## Access Compliance Report Public Rights-of-Way (Curb Ramps)

Intersection ID: N/A Main Street: PERIMETER\_PY Cross Street: N/A Location: NW

ADA ID: B7EA03637E29 Ramp Type: PerpDiag Initial Pass/Fail: Fail Overall Compliance: No Severity Score: 12.5

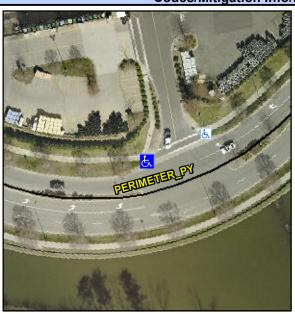
PROW/ADA:
Not Found, R304.2.2

r leid Measurements/Component Compnance					
Compliance Description		Data	Compliance Description		Data
N/A	Ramp Length (in)	52.0	No	Ramp Slope (%)	9.0
Yes	Ramp Width (in)	48.0	Yes	Ramp XSlope (%)	0.7
N/A	Flare Type LT	N/A	N/A	Flare Type RT	N/A
N/A	Flare Slope LT (%)	N/A	N/A	Flare Slope RT (%)	N/A
N/A	Flare Traversable LT?	No	N/A	Flare Traversable RT?	No
N/A	Landing Length (in)	N/A	N/A	DWS Provided?	N/A
N/A	Landing Width (in)	N/A	N/A	DWS Contrast?	N/A
N/A	Landing Slope (%)	N/A	N/A	DWS Length (in)	N/A
N/A	Landing X Slope (%)	N/A	N/A	DWS Full Width?	N/A
N/A	Landing Curb? (Y/N)	N/A	N/A	DWS Offset (in)	N/A
N/A	Shared Landing?	N/A			
N/A	Gutter Ponding?	N/A	N/A	Gutter Slope (%)	N/A
N/A	Gutter Lip Ht (in)	N/A	N/A	Gutter X Slope (%)	N/A
N/A	Painted X Walk1?	No	N/A	Painted X Walk2?	Yes
	X Walk 1 Direction	To S		X Walk 2 Direction	To NE
N/A	X Walk 1 Width (in)	N/A	N/A	X Walk 2 Width (in)	71.0
	X Walk 1 Slope (%)	2.7		X Walk 2 Slope (%)	0.8

Remove & Replace Curb Ramp With
Two New Directional Ramps or
Equivalent.
